# **28F016SA/DD28F032SA SPECIFICATION UPDATE**

Release Date: July 1996

Order Number: 297408-006

The 28F016SA/DD28F032SA may contain design defects or errors known as errata. Characterized errata that may cause the 28F016SA/DD28F032SAs' behavior to deviate from published specifications are documented in this specification update.

**Example System Software Flowchart That Will Not Encounter  
“Completion with Command Error or Invalid Device Operation” Condition**

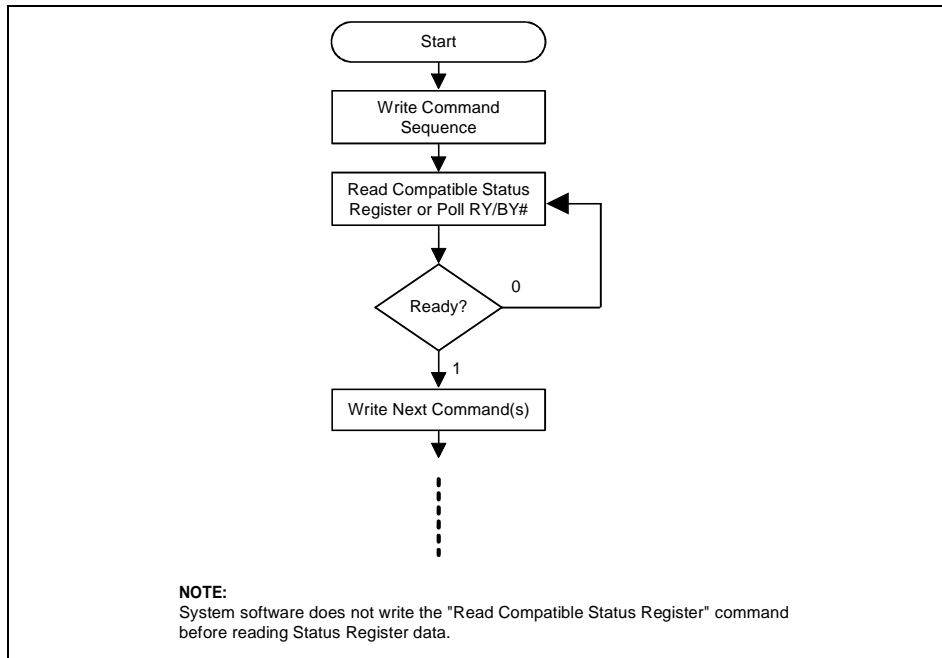
**PROBLEM:** Systems in which software, after initiating device automation via a queueable command sequence, writes another command(s) to the device before automation completes may initiate unintended device operations.

Systems that poll the RY/BY# pin or WSMS bit (CSR.7) for “Ready” indication before writing another command to the device will not encounter this errata. This is illustrated in the *Example System Software Flowchart, etc.* figure below, and in flowcharts 11-1 and 11-2 (without erase suspend) of the *16-Mbit Flash Product Family User’s Manual*.

**WORKAROUND:** The following options listed below outline possible corrective actions required to avoid this errata. (Note: Any one of the options will eliminate this errata.)

**Timing Waveform Showing Specification Ranges That Will Not Cause the “Completion with Command Error or Invalid Device Operation” Condition**

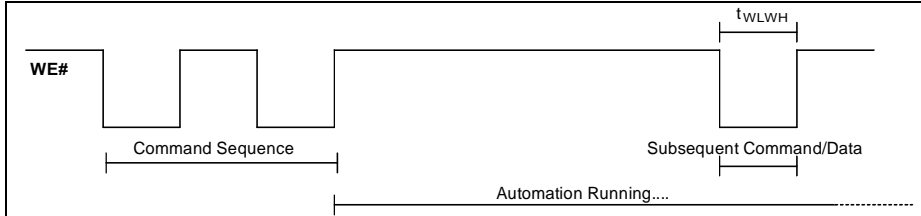
For WE#-Controlled Write Operations, a WE# pulse width defined by the ranges of parameter  $t_{WLWH}$  in the table below, will result in a system that does not exhibit this errata. (Note: timings are also bounded by specifications in the device datasheet). When performing CE#-Controlled Write Operations, this restriction equally applies to the CE# pulse width ( $t_{ELEH}$ ).

V <sub>CC</sub> Supply Voltage	$t_{WLWH}$	$t_{ELEH}$
5V	<75 ns	<75 ns
3.3V	<100 ns	<100 ns

**Erase Suspend to Read Array with Compatible Status Register**

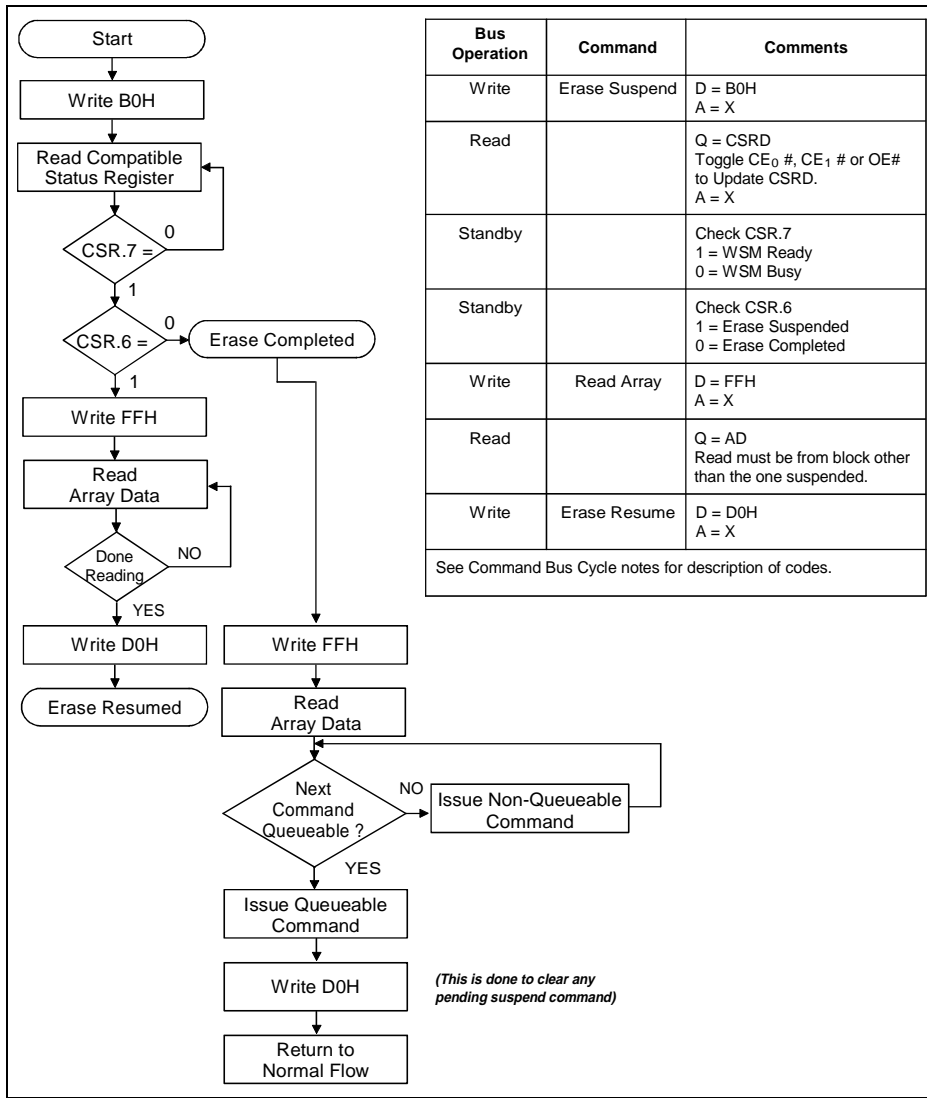
**PROBLEM:** If an Erase Suspend command is issued after completion of the Erase Cycle (either Single Block Erase or Erase All Unlocked Blocks) or too late in the Erase cycle, such that the Erase completes before the Status Register Suspend bit is set, the device will queue this unserviced Suspend request.

- A. If another Erase command is issued at some time later, the device then assumes that the pending Suspend request is still valid and will automatically Suspend the current Erase.
- B. If any queueable command is in the command queue waiting for execution while another queueable command is in progress, the Write State Machine will suspend its operation after completing the current command. (Refer to the *16-Mbit Flash Product Family User's Manual*, Section 11-1 for the queueable command list.)

**WORKAROUND:** Intel developed a software workaround to this errata, by inserting a second Resume command (DOH) following any queueable command in the Erase Suspend flowcharts. Both Erase Suspend to Read Array flowcharts (*16-Mbit Flash Product Family User's Manual*, Figures 11-3 and 11-12) detailing this workaround are attached to this errata (see the *Erase Suspend to Read Array with Compatible Status Register* and *Erase Suspend to Read Array with Extended Status Register* figures, which follow). This erratum results in the *Erase Suspend with Compatible Status Register* flowchart being incompatible with the 28F008SA *Erase Suspend* flowchart.
